## **Technical Bulletin**

TITLE: Peli Micro Case™ Design Changes

PRODUCTS AFFECTED: Peli's 1010, 1020, 1030, 1040, 1050, 1060 Micro Cases/ i1010 \*iPod® Case

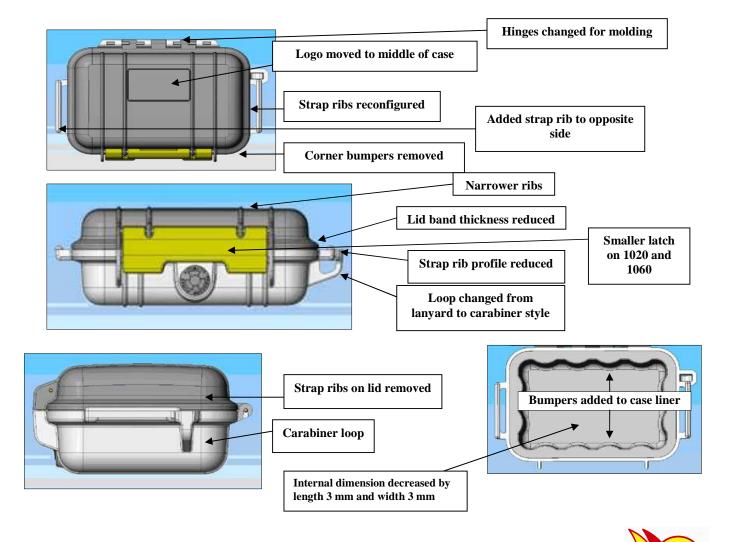
- The latches on the Micro Cases have been changed from solid matching colors to clear polycarbonate.
- Internal case dimension has decreased by length 3 mm and width 3 mm.
- The i1010 case exterior will change but the interior will remain the same.
- New part numbers have been created (the list has already been sent to you).

New carabiner acts as hook and packaging attachment
